Access Compliance Report

Public Rights-of-Way

(Curb Ramps)

Intersection ID: 11209	Main Street: W_10TH_ST	Cross Street: N_SMITH_ST	Location: S
ADA ID: 47A94D0ED76B	Ramp Type: Perp	Initial Pass/Fail: Fail	Overall Compliance: No
Severity Score: 41.25			
Codes/Mitigation Info/Possible Solution		Field Measurements/Component Compliance

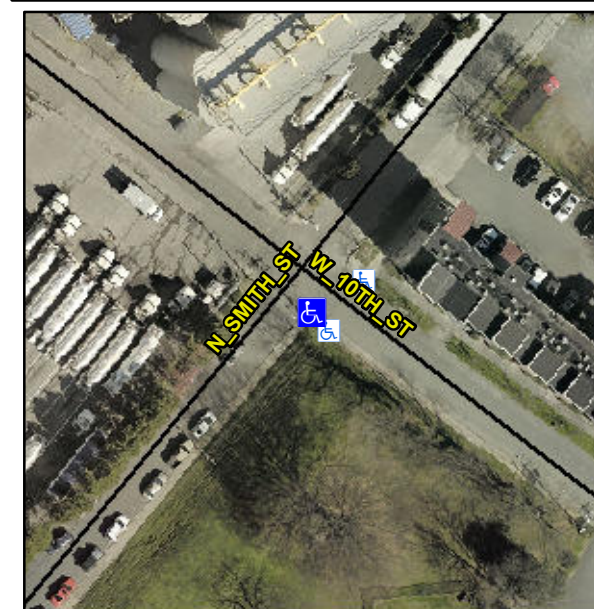
R304.2.2, R304.5.3, R302.7

Compliance	Description	Data	Compliance	Description	Data
N/A	Ramp Length (in)	45.0	No	Ramp Slope (%)	13.3
Yes	Ramp Width (in)	48.0	No	Ramp XSlope (%)	3.3
N/A	Flare Type LT	N/A	N/A	Flare Type RT	N/A
N/A	Flare Slope LT (%)	N/A	N/A	Flare Slope RT (%)	N/A
N/A	Flare Traversable LT?	N/A	N/A	Flare Traversable RT?	N/A
N/A	Landing Length (in)	N/A	N/A	DWS Provided?	N/A
N/A	Landing Width (in)	N/A	N/A	DWS Contrast?	N/A
N/A	Landing Slope (%)	N/A	N/A	DWS Length (in)	N/A
N/A	Landing X Slope (%)	N/A	N/A	DWS Full Width?	N/A
N/A	Landing Curb? (Y/N)	N/A	N/A	DWS Offset (in)	N/A
N/A	Shared Landing?	N/A			
N/A	Gutter Ponding?	N/A	N/A	Gutter Slope (%)	N/A
N/A	Gutter Lip Ht (in)	N/A	N/A	Gutter X Slope (%)	N/A
N/A	Painted X Walk1?	No	N/A	Painted X Walk2?	N/A
	X Walk 1 Direction	To NE		X Walk 2 Direction	N/A
N/A	X Walk 1 Width (in)	N/A	N/A	X Walk 2 Width (in)	N/A
	X Walk 1 Slope (%)	5.4		X Walk 2 Slope (%)	N/A
	X Walk 1 X Slope (%)	3.1		X Walk 2 X Slope (%)	N/A

N/A	Ramp inside XWalk1?	N/A	N/A	Ramp inside XWalk2?	N/A
	Road Slope (%)	3.1	N/A	Clear Space?	N/A
	Road X Slope (%)	5.4	N/A	Clear Space to XWalk (in)	N/A
N/A	Any Obstructions?	N/A	N/A	Storm Grate/Utility Hazard?	N/A
	Obstruction Type			Storm Grate/Utility Type	
		N/A			N/A
		No		Surface Condition? (G/P)	Poor

Remove & Replace Entire Ramp.
